WATER PERMIT NO. 1712-1

**SOUTH DAKOTA
WATER PERMIT NO. 1712-1**

**RECOMMENDATION OF CHIEF ENGINEER FOR WATER PERMIT
APPLICATION NO. 1712-1, Francis and Connie Connolly**

REPORT ON
WATER PERMIT APPLICATION NO. 1712-1
Francis & Connie Connolly
February 18, 2000

PLAN VIEW
(NO SCALE)

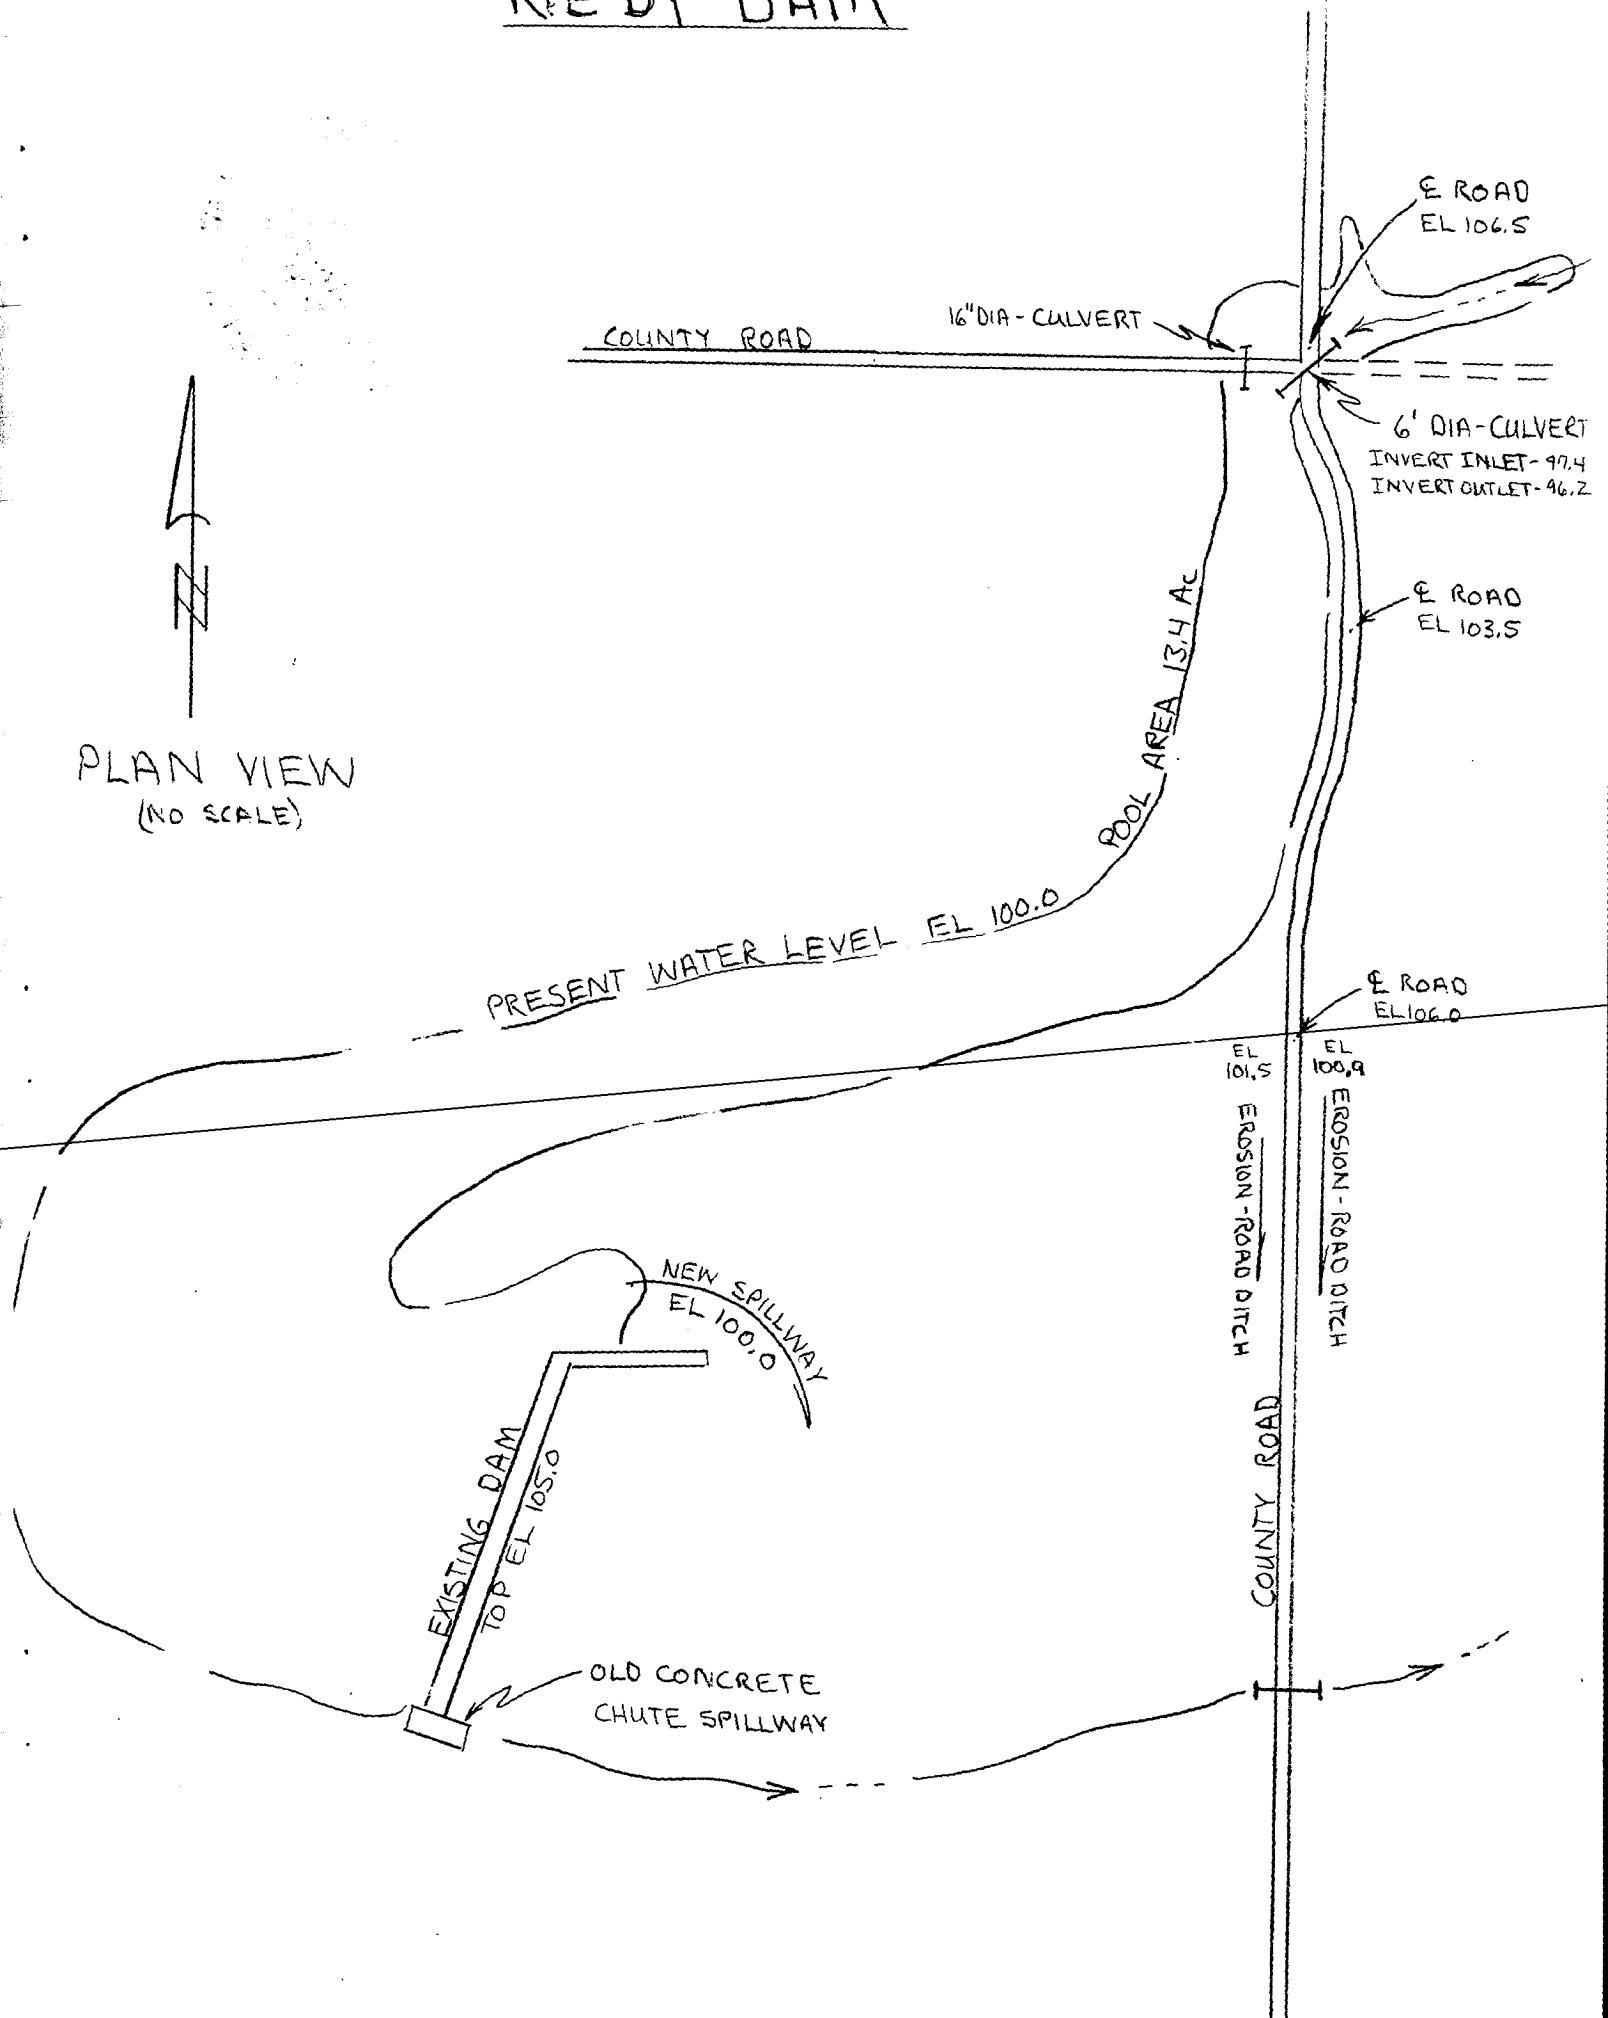
Top of Dam Elev. - 105
* Spillway Elev. - 100 } HT = 19 ft.
Dis. Top Elev. - 86

Cat. 3 - Low Hazard Dam

Normal Storage Capacity = 54
Max Storage Capacity = 150

* Breached dam - Repaired
in 1999 by blocking off
breached P. Spillway. Owner
agreed to lower 2nd Spillway
to Elev. 99

HT x Max. Capacity = $19 \times 150 = 2850 < 3000 \therefore$ 25 year
Min. Spillway Design

1. - Topo Map - OK
2. - Dam Axis Profile - OK
3. - Dam Max X-Sec. - OK
4. - Area - Capacity - OK
5. - Outlet details - N/A - OK
6. - Spillway Rating - OK
7. - Spillway Details - OK
8. - Specs - N/A - OK
9. - LPP - Cat 3 N/A - OK
